ADDENDUM NO. 1

**NIMITZ HIGHWAY AND ALA MOANA BOULEVARD RESURFACING,
SAND ISLAND ACCESS ROAD TO VICINITY OF PIIKOI STREET**

FEDERAL AID PROJECT NO. NH-092-1(030)

The following amendments shall be made to the Bid Documents:

TYPICAL DETAIL FOR CONSTRUCTION SIGNS
 ON TWO LANE OR MULTILANE UNDIVIDED LOW SPEED HIGHWAY

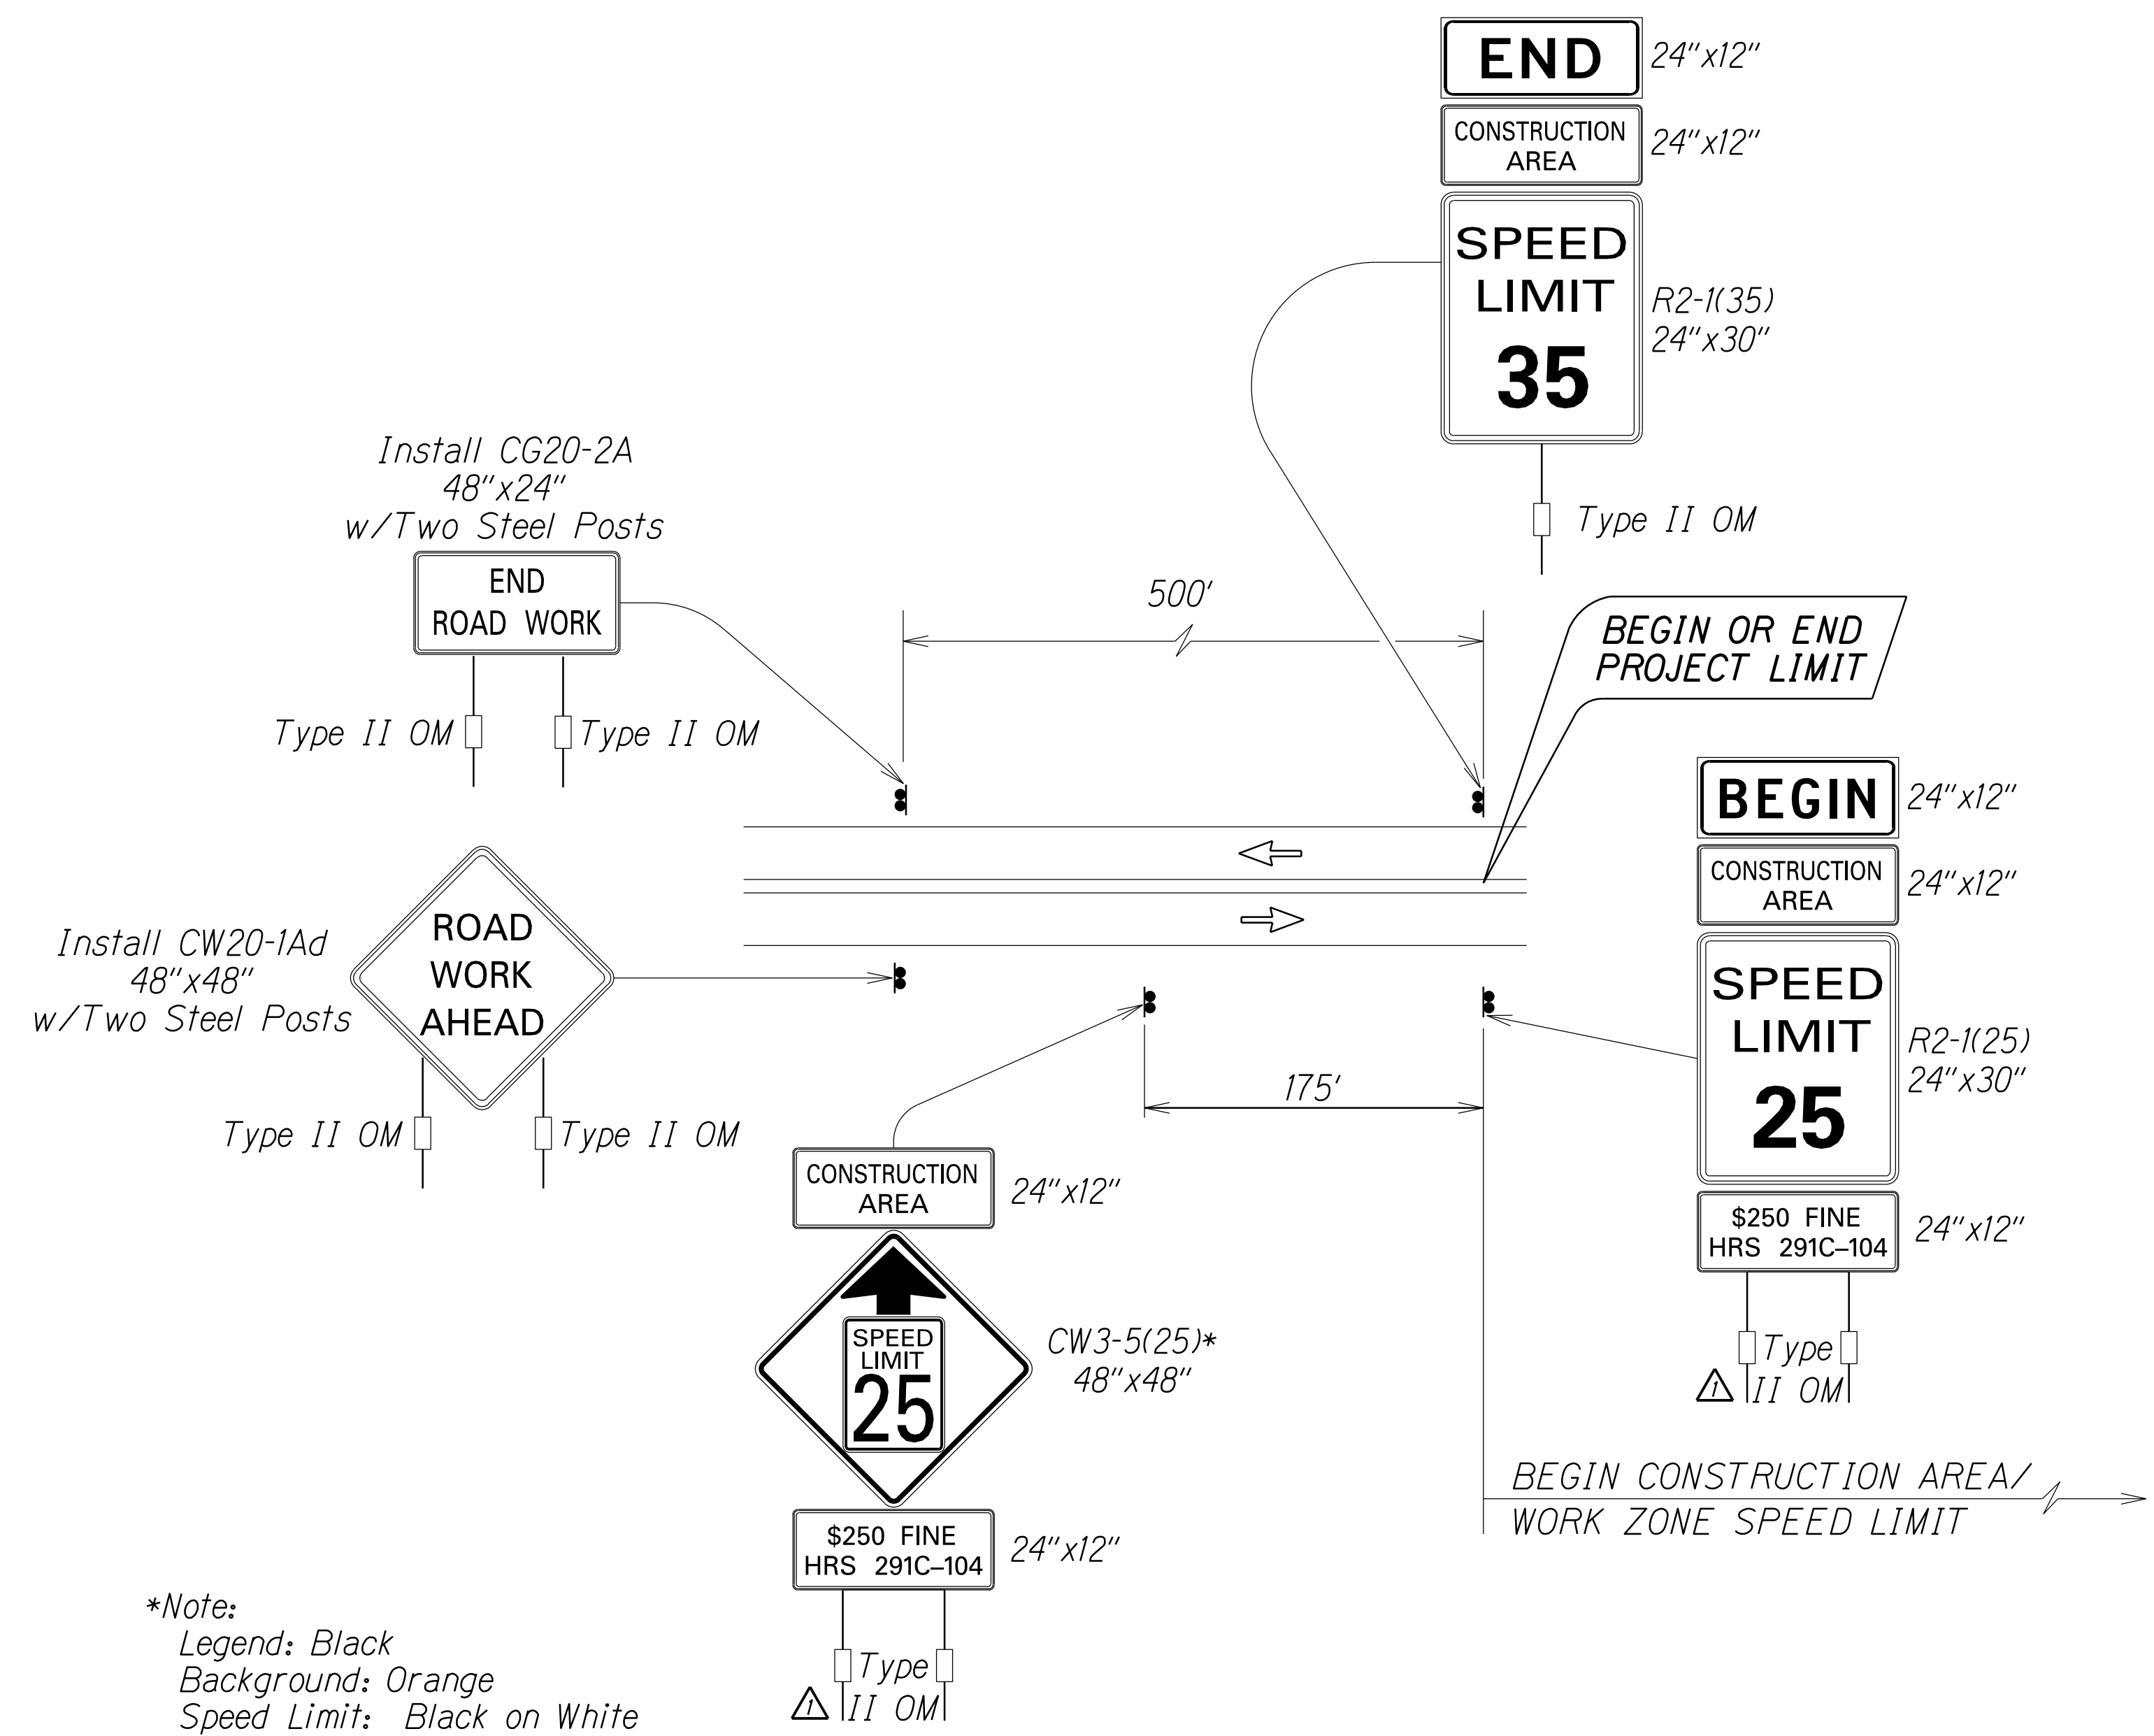
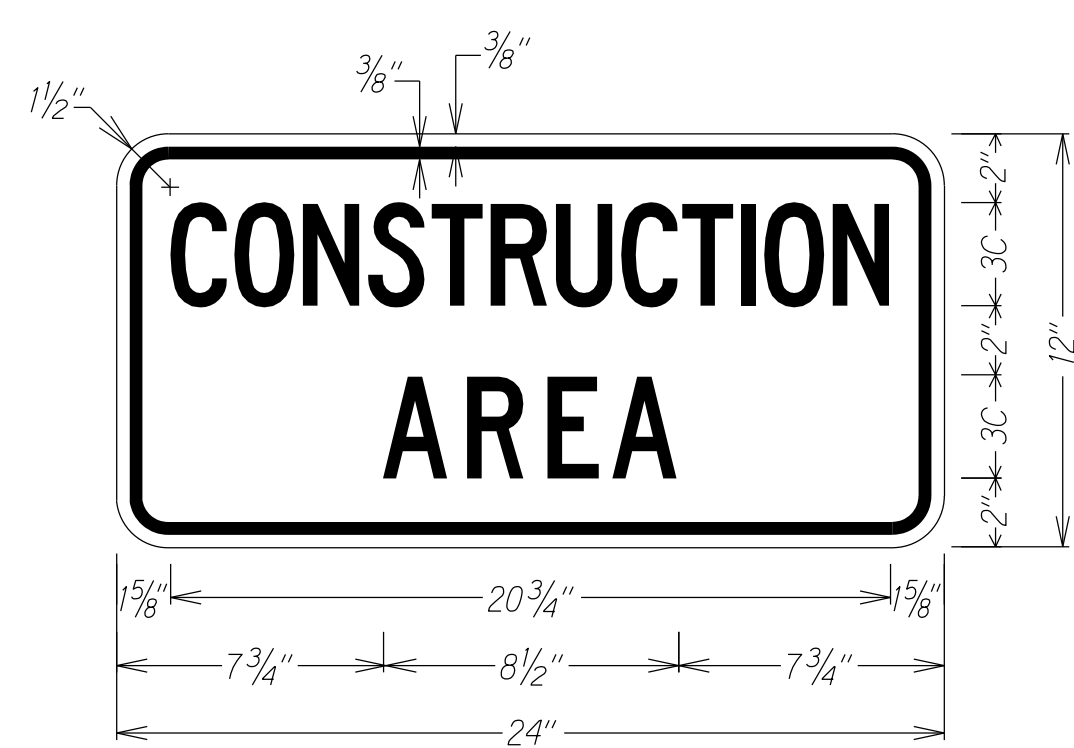
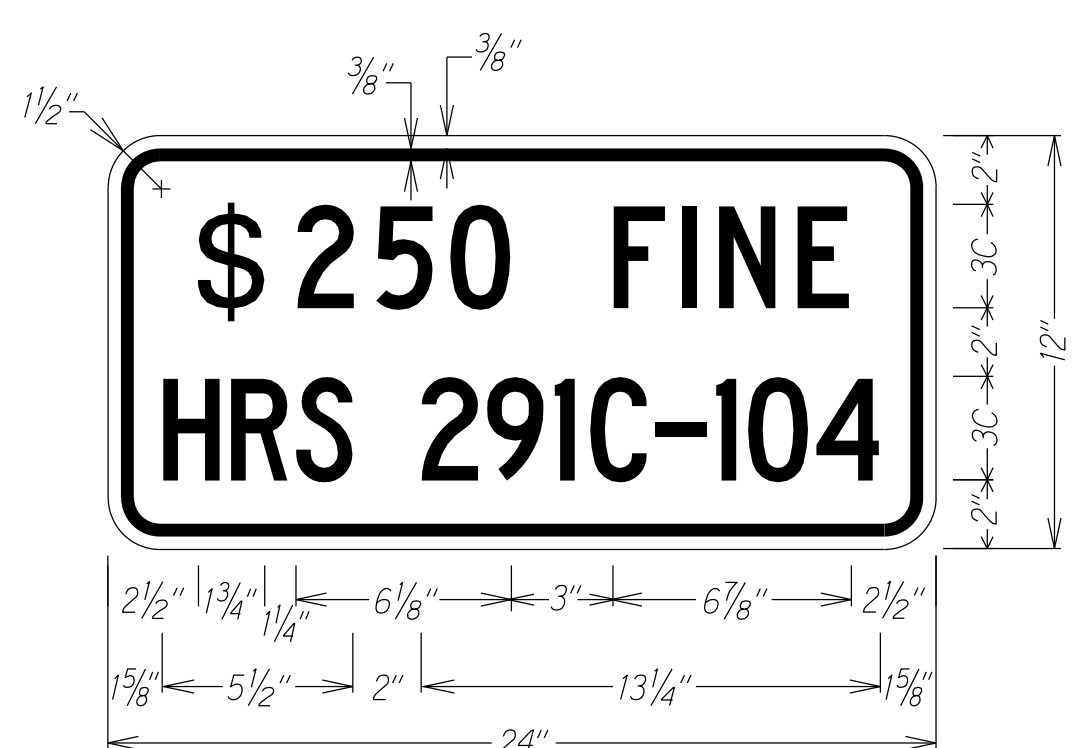
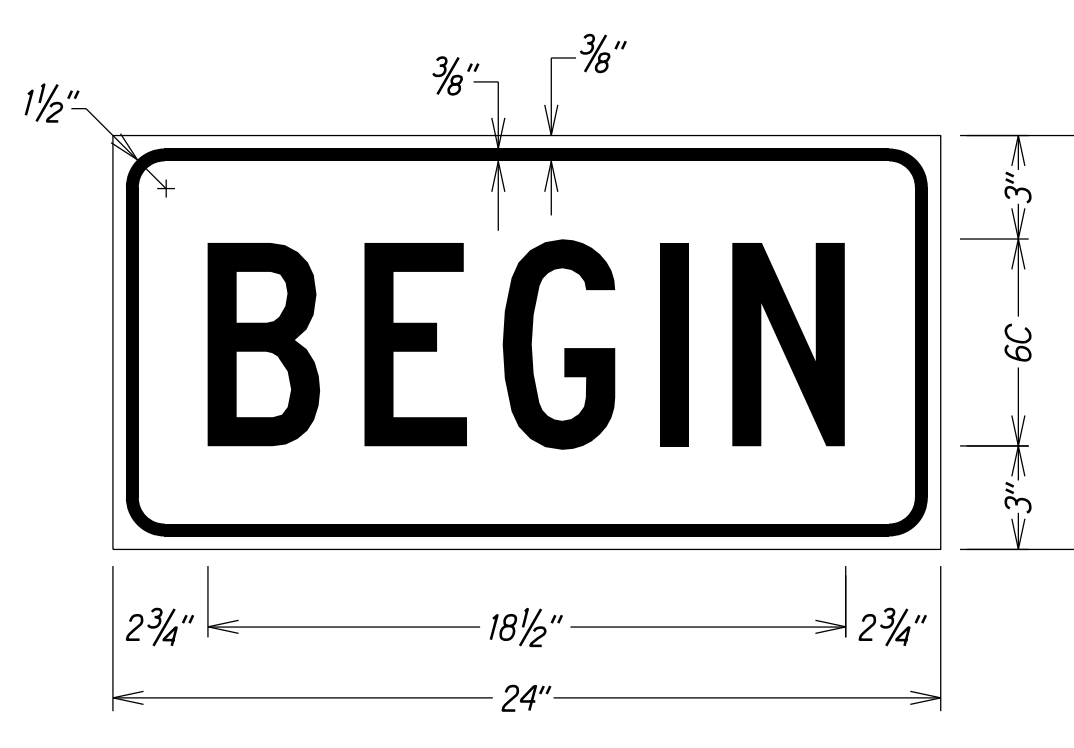
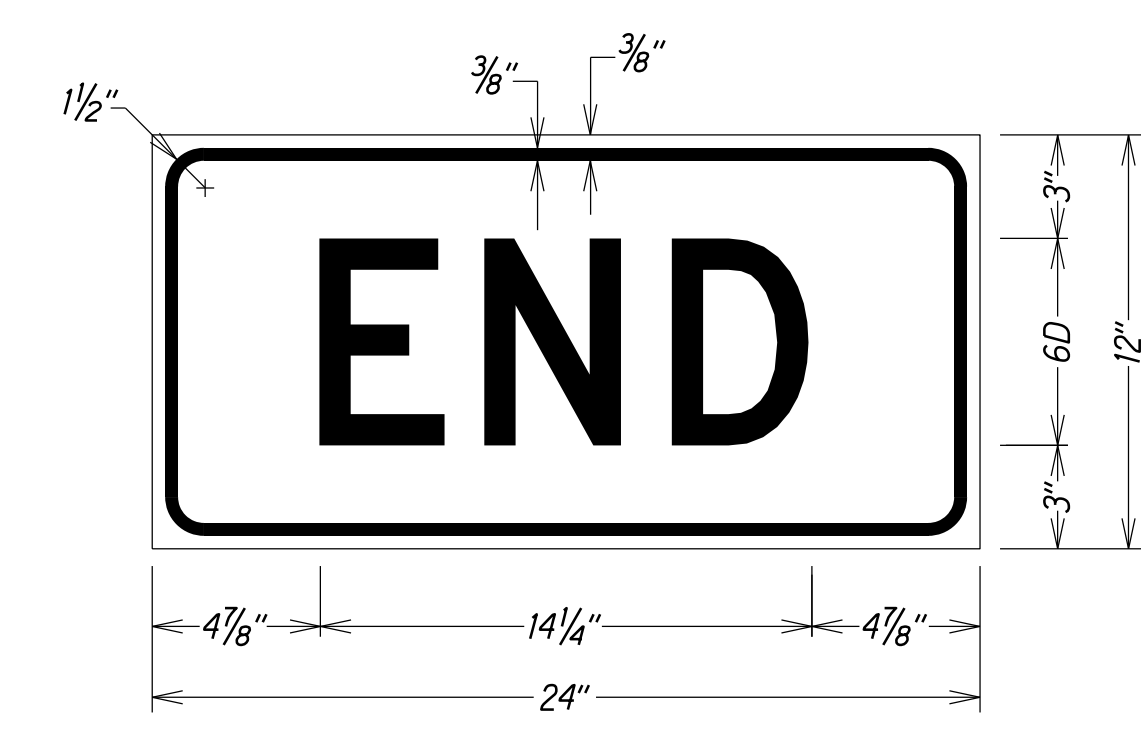
2/11/21	Change sign assemblies to show two posts.
DATE	REVISION
STATE OF HAWAII DEPARTMENT OF TRANSPORTATION HIGHWAYS DIVISION	
LOW SPEED UNDIVIDED HIGHWAY	
WORK ZONE SIGNING PLAN, NOTES & DETAILS	
NIMITZ HIGHWAY & ALA MOANA BOULEVARD RESURFACING	
Sand Island Access Rd. to Vic of Piikoi St. Federal-Aid Project No. NH-092-1(030)	
Scale: As Shown	Date: August, 2020
SHEET No. T4 OF 20 SHEETS

10. On Sheet 34 can you please clarify the size of sign for - Construction Area/Speed Limit 25 Ahead/\$250 Fine Sign Set on Post - Either the size of Speed Limit 25 Ahead sign needs to be reduced to 30"x30" or 36"x36" to use one post, or two posts need to be used. Can this be clarified?

All the sign(s) shown on Sht. 33 and 34 with total sign areas bigger than 10 s.f. should have two (2) sign support posts per Standard Plan TE-03B. We will revise the two drawings accordingly. Refer to Sheets ADD. 33 and ADD. 34.

See response to question 9.
